Department of Transportation

MEMORANDUM

SUBJECT: ZC Case No. 22-13 – 4500 Massachusetts Avenue NW (Wesley Theological Seminary)

Figure 1 | Proposed Site Circulation

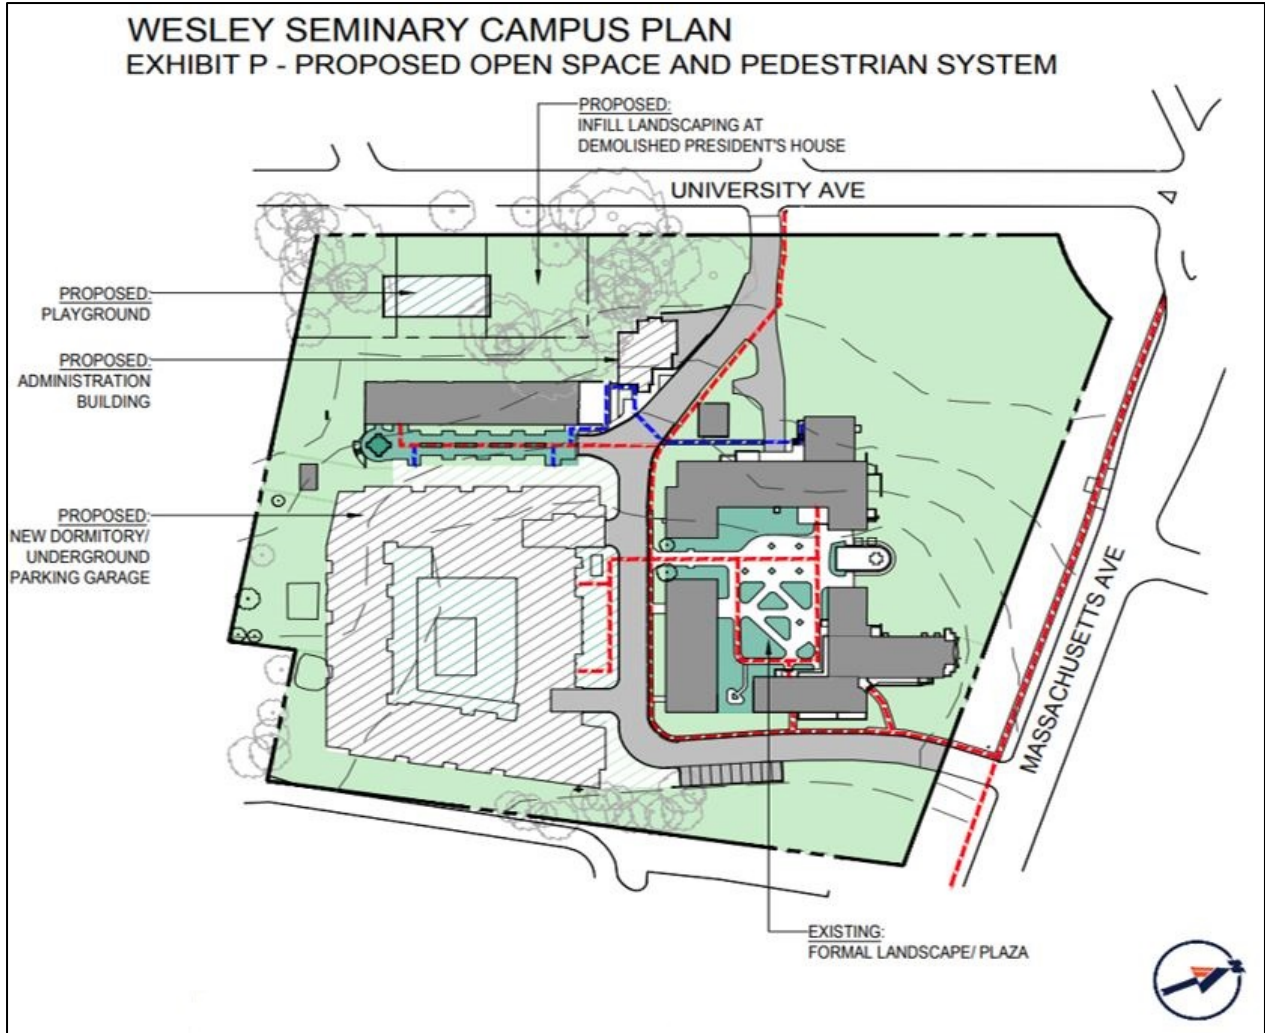
Pedestrian access is also mainly provided from Massachusetts Avenue as there is no sidewalk on University Avenue. There is a pedestrian connection between the Wesley Seminary and American University that is controlled by a pedestrian gate and key fob. No pedestrian access changes are proposed with the 2022 campus plan, however, DDOT is requesting the missing sidewalk, curb ramps, ADA facilities, and leadwalk be installed on the University Avenue side of Campus.

Figure 4 | Existing Pedestrian Facilities

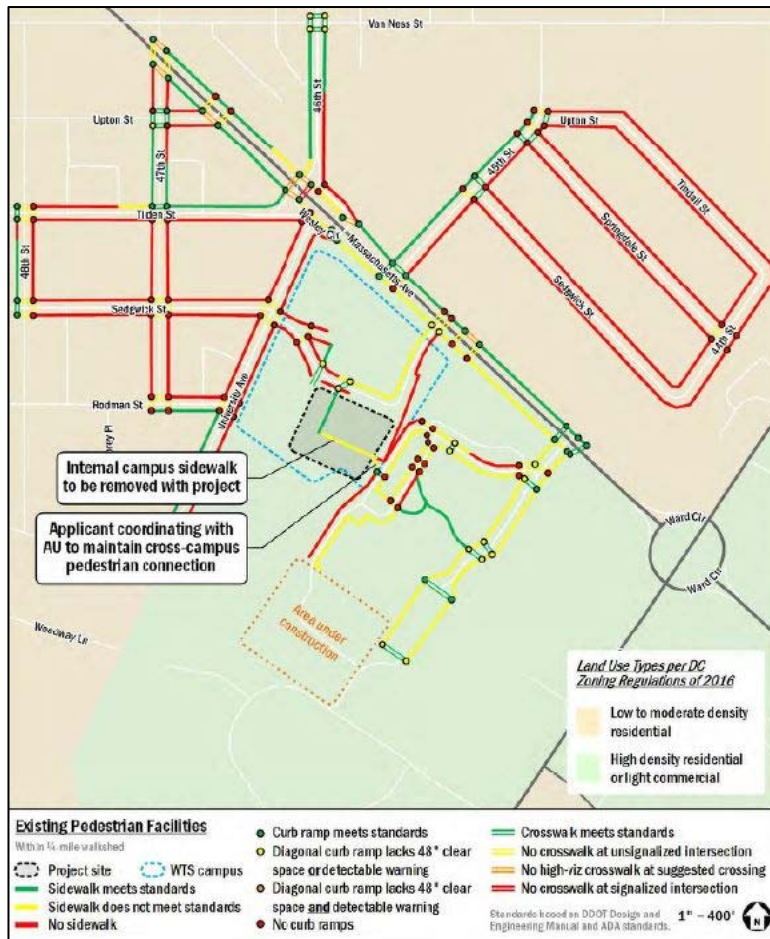
The Applicant’s inventory of the pedestrian infrastructure in the vicinity of the campus, as shown in Figure 4 shows that there are significant missing connections in the study area, particularly along University Avenue. To help offset the projected increase in traffic volumes and to encourage non-automotive travel to and from Campus, DDOT requests the Applicant commit in the TDM Plan and PMP to installing the missing sidewalk along University Avenue, including the missing ADA facilities with a leadwalk into campus, and install wayfinding signage on-site for residents seeking to walk to American University campus.

- Prior to the Spring 2024 semester, fund and construct the following pedestrian improvements:
 - A sidewalk along the east side of University Avenue NW between Massachusetts Avenue and Rodman Street, subject to DDOT approval, with a leadwalk into campus at the site driveway.

- All missing curb ramps, crosswalks, and signage at the intersections of University Avenue at Rodman Street and University Avenue at Sedgwick Street/Site Driveway, subject to DDOT approval; and

Figure 5 | Existing, Planned, and Proposed Bicycle Facilities

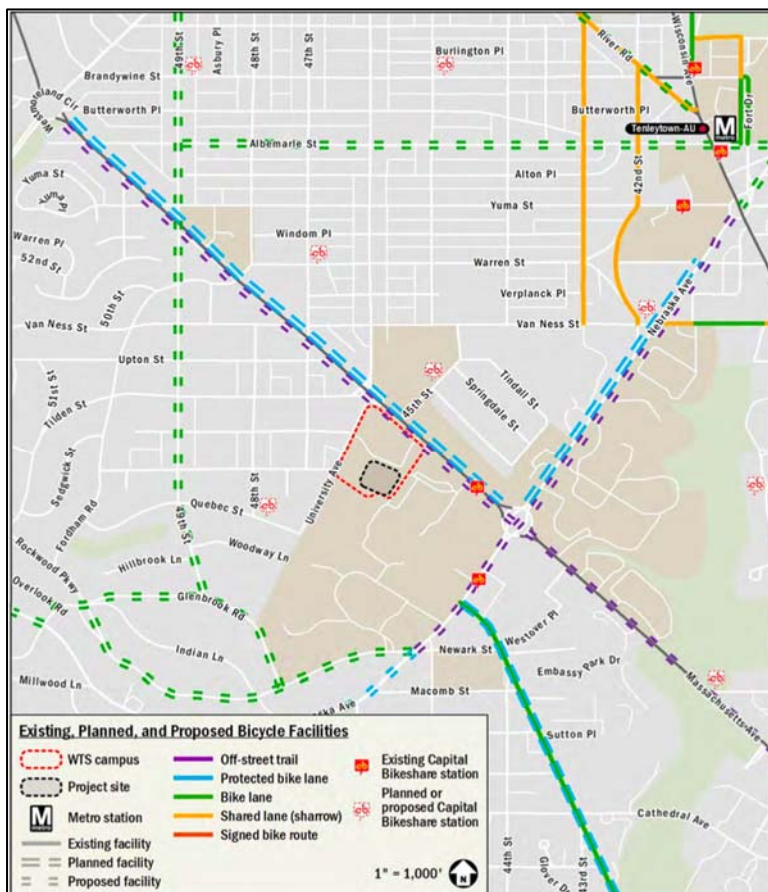
The Applicant will be upgrading all on-campus short-term bicycle parking to U-racks and installing an additional 10 bicycle racks due to increased demand. As shown on Figure 5 below, there are currently not many existing bicycle lanes or trails within ½ mile of the site, however there are several planned facilities in the future.
